TO: Jessica McCallum, Kevin Roth, Kimley-Horn
FROM: Amber Wood Hicken, Planner I
DATE: 1/24/24
SUBJECT: Parker Pointe F1 Lot 2A, McDonald's – Site Plan, SP23-070
Review Comments 02

PARKER POINTE SUBDIVISION FILING NO. 2, LOT 2A

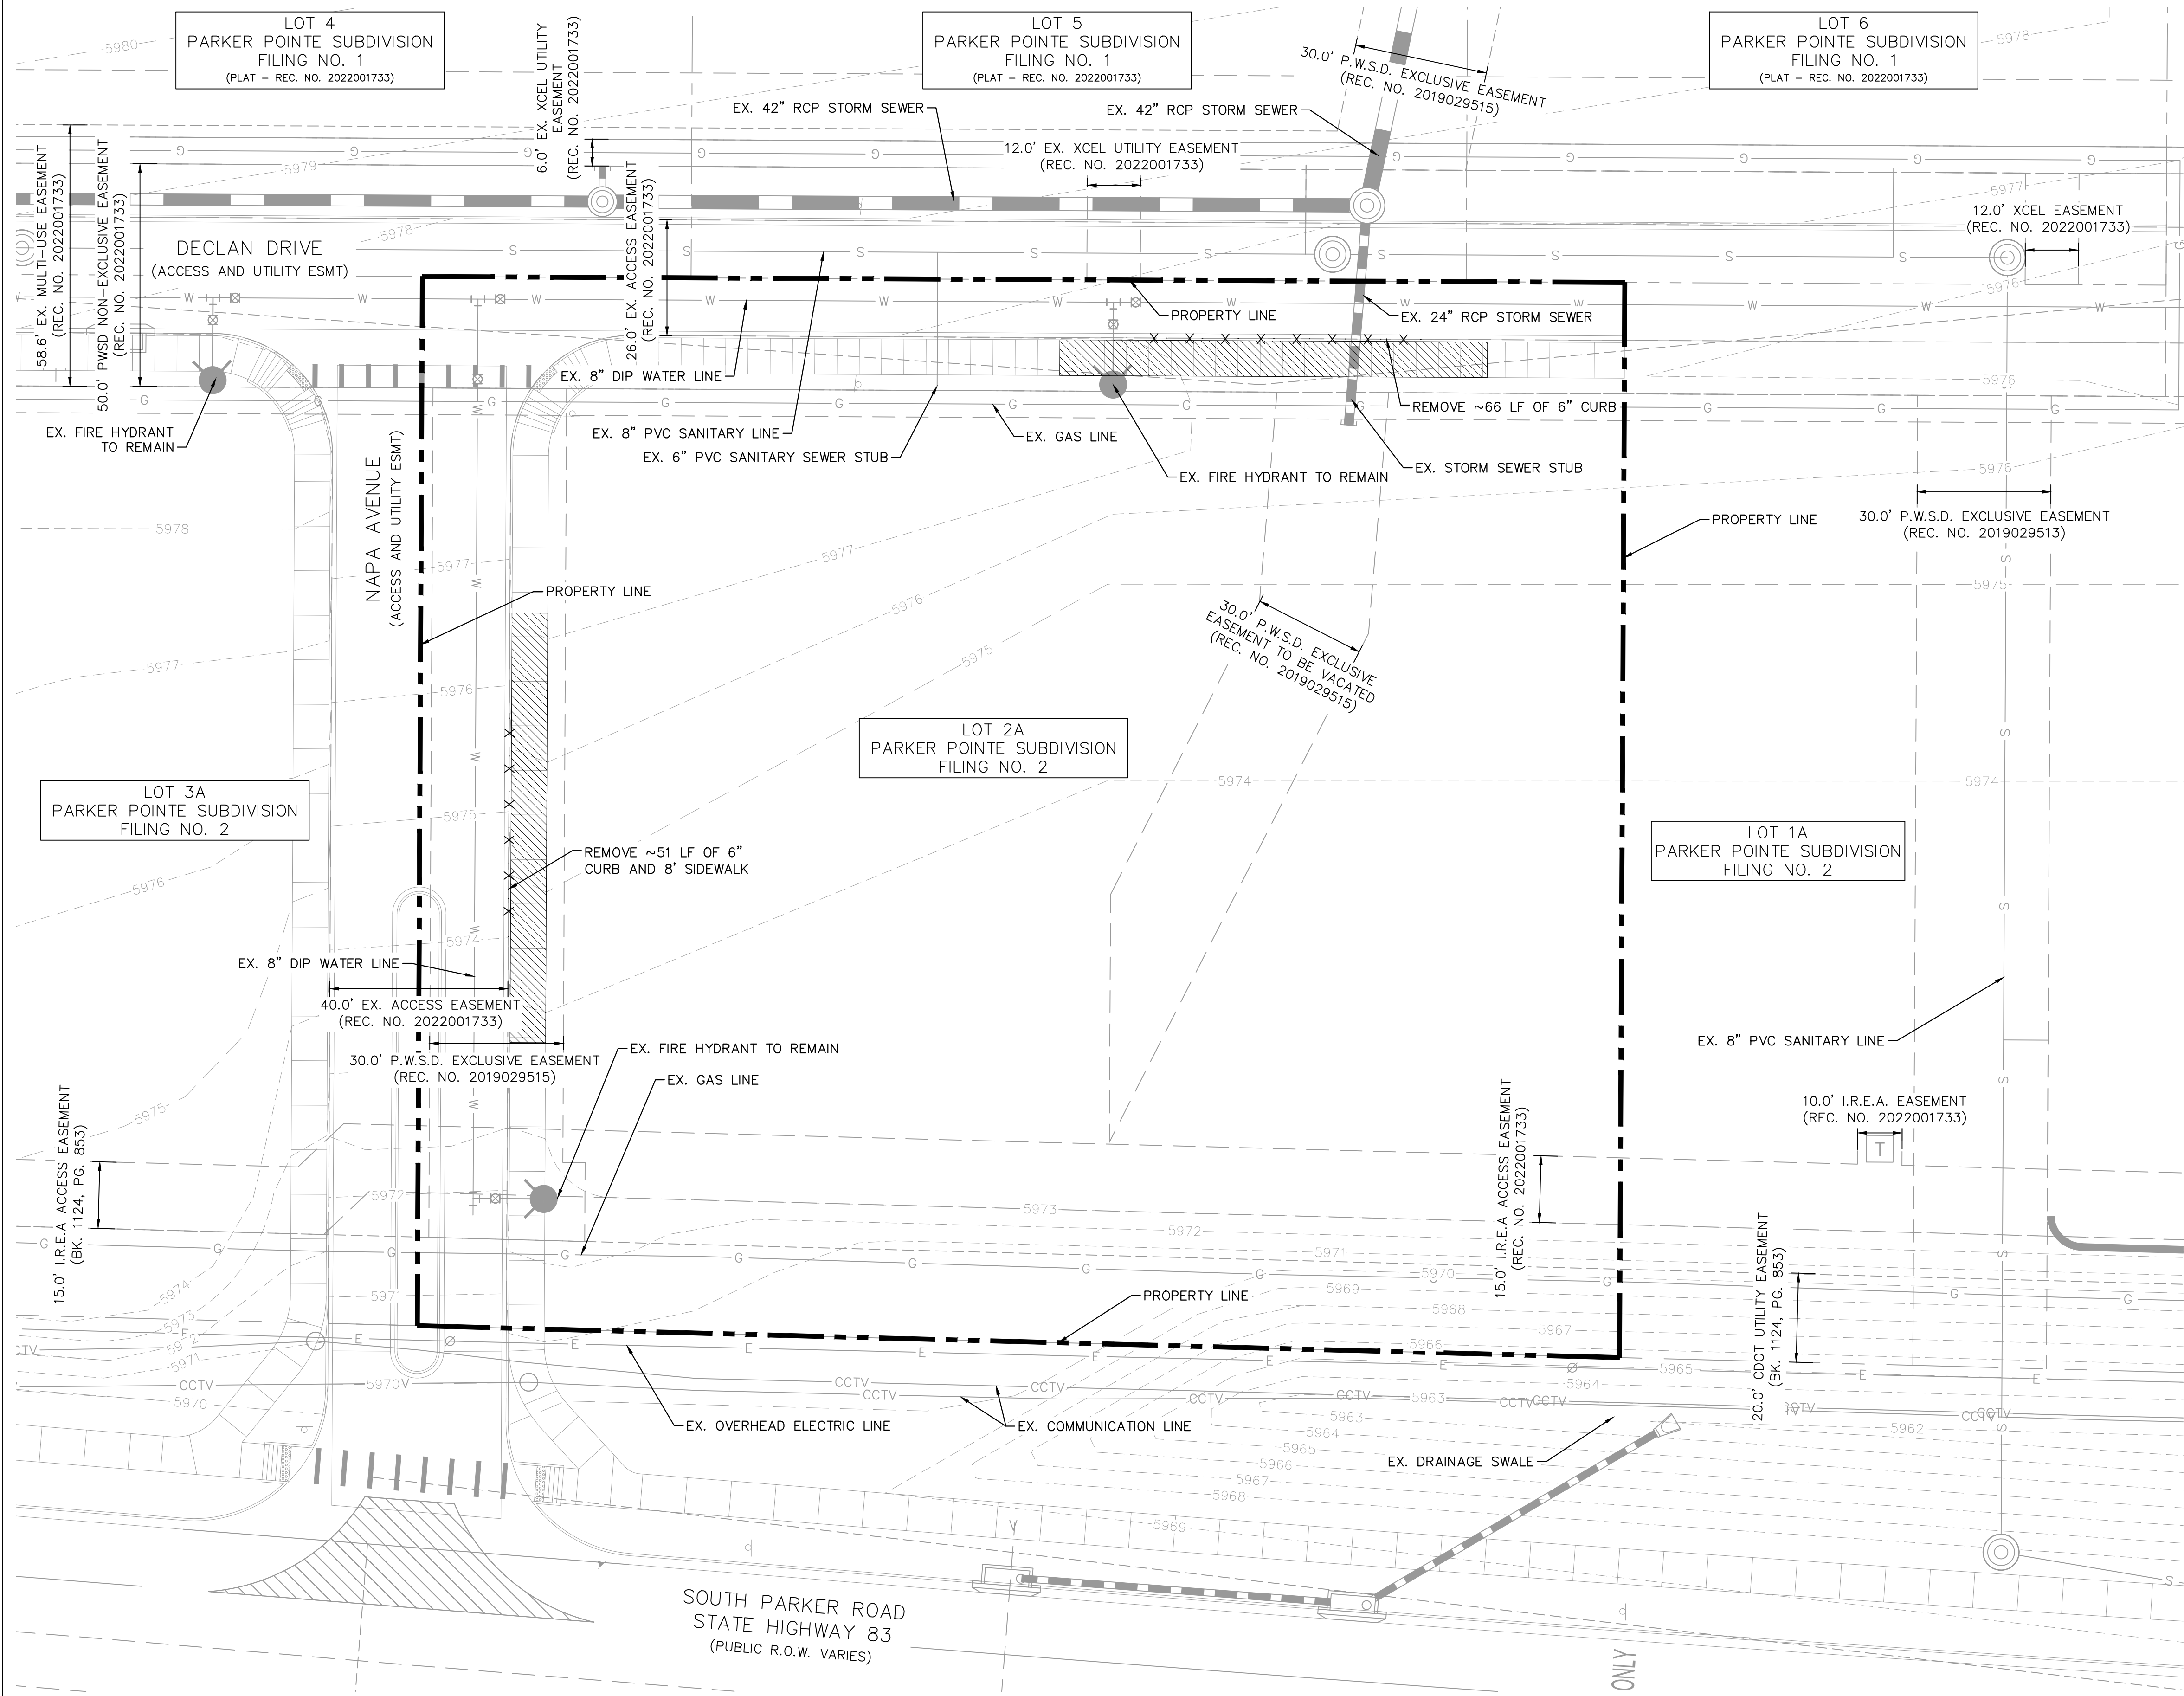
please provide parking counts for a dine-in restaurant as well (can be in an email, 1 space per 3 persons rated capacity) so staff can analyze both options

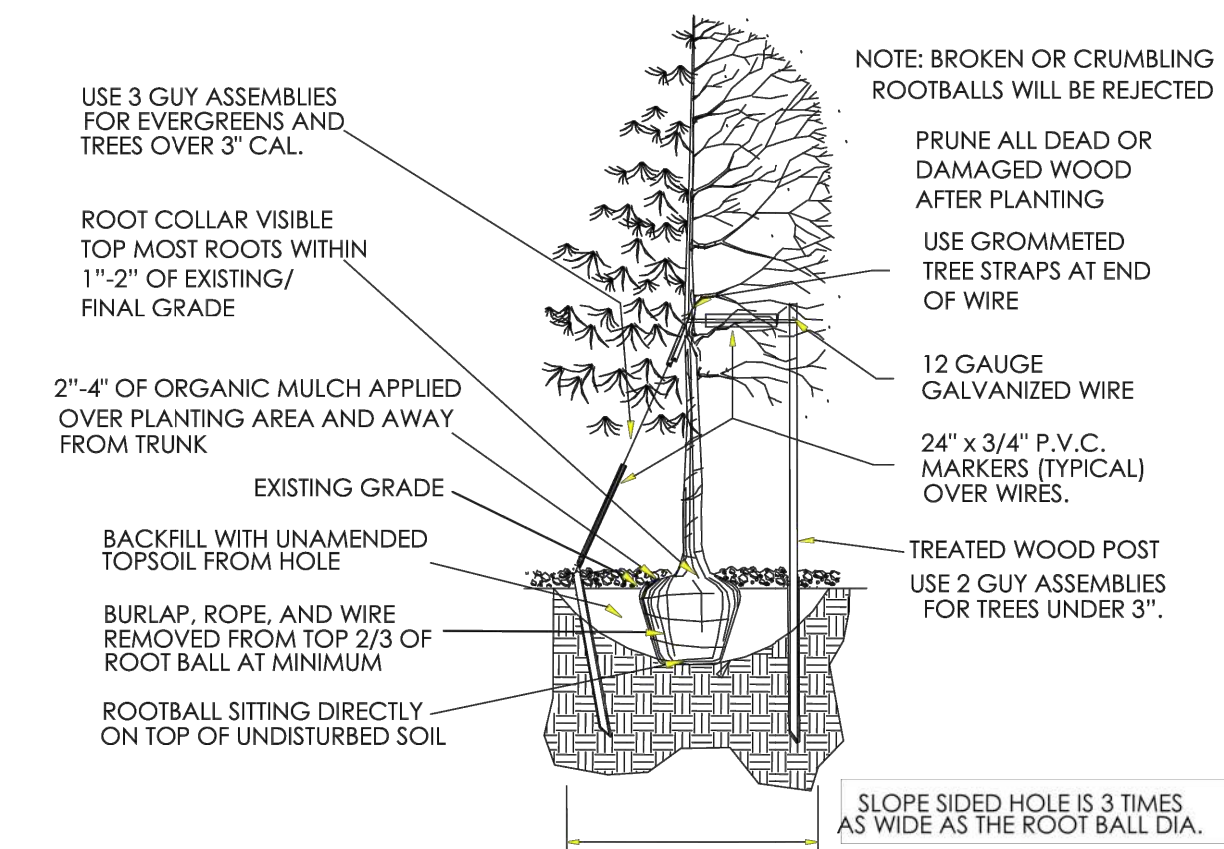
1. THE SITE CONTAINS LESS THAN 80 PARKING STALLS; PARKING LOT INTERIOR LANDSCAPING SHALL NOT BE APPLIED.
- plant schedule shows
288
- plant schedule shows
28 total, 13 evergreen
